CIVIL ENGINEERING ASSOCIATES, INC.

October 30, 2012

Re: Intersection Improvements at Weed Road and Shelburne Falls Road

WEED RD

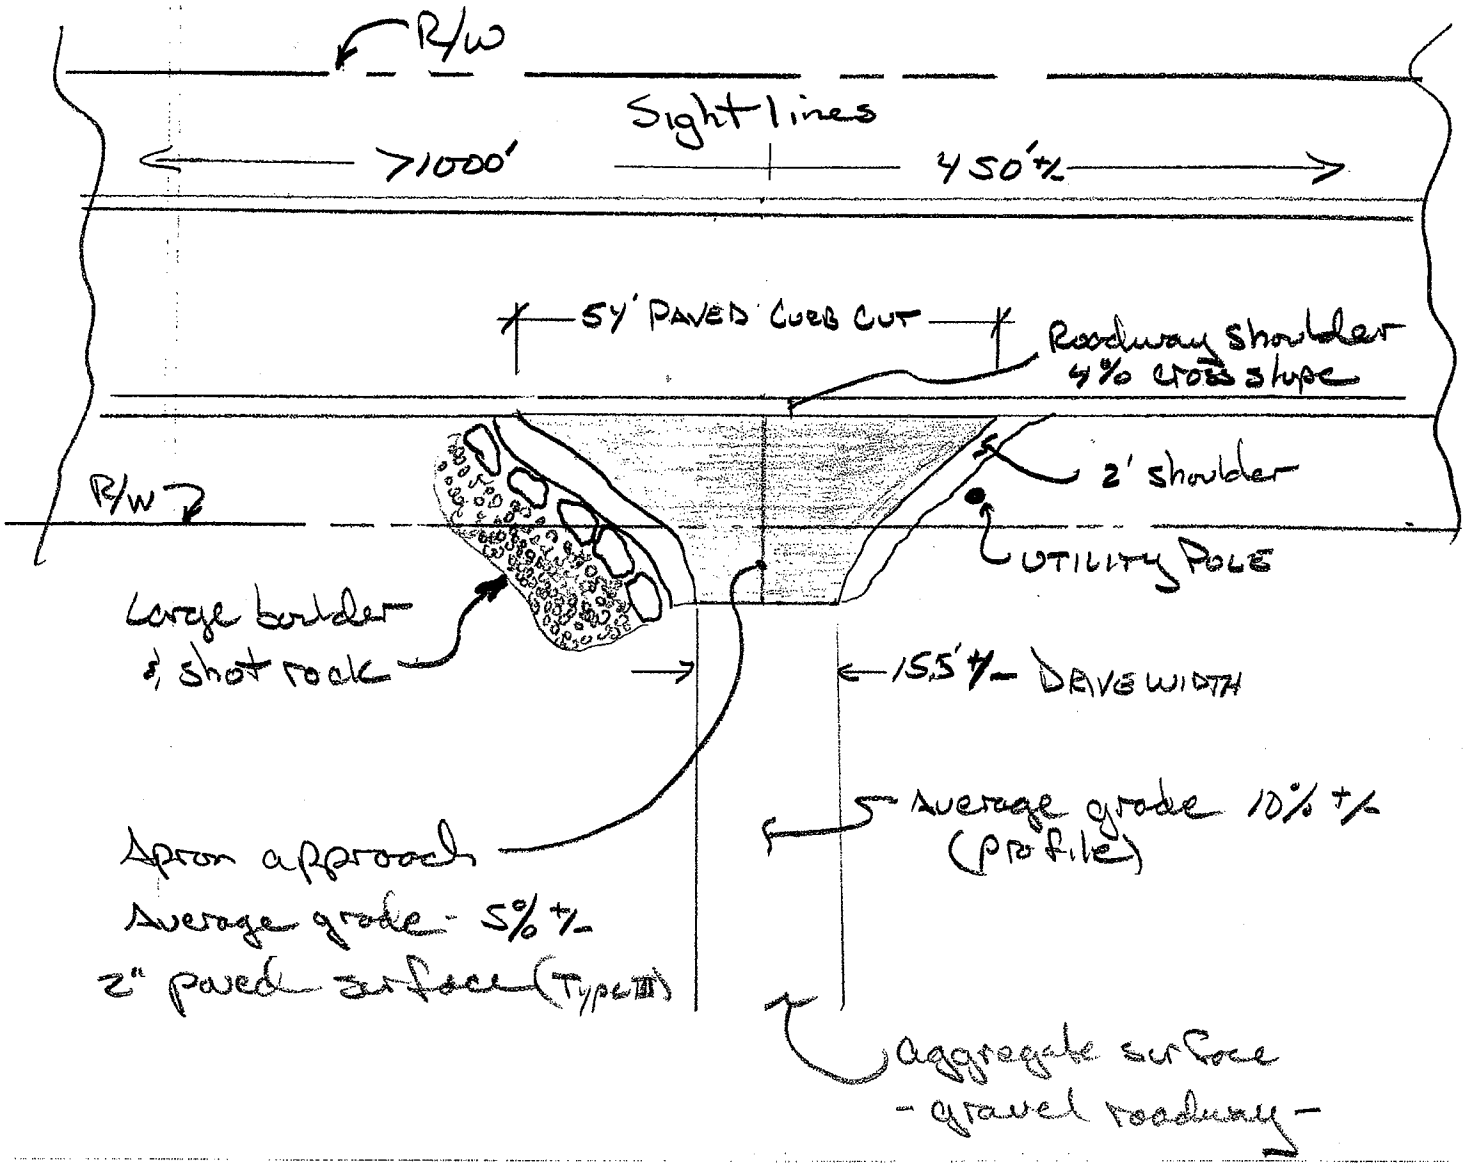
there are 4 pollouts
for passing
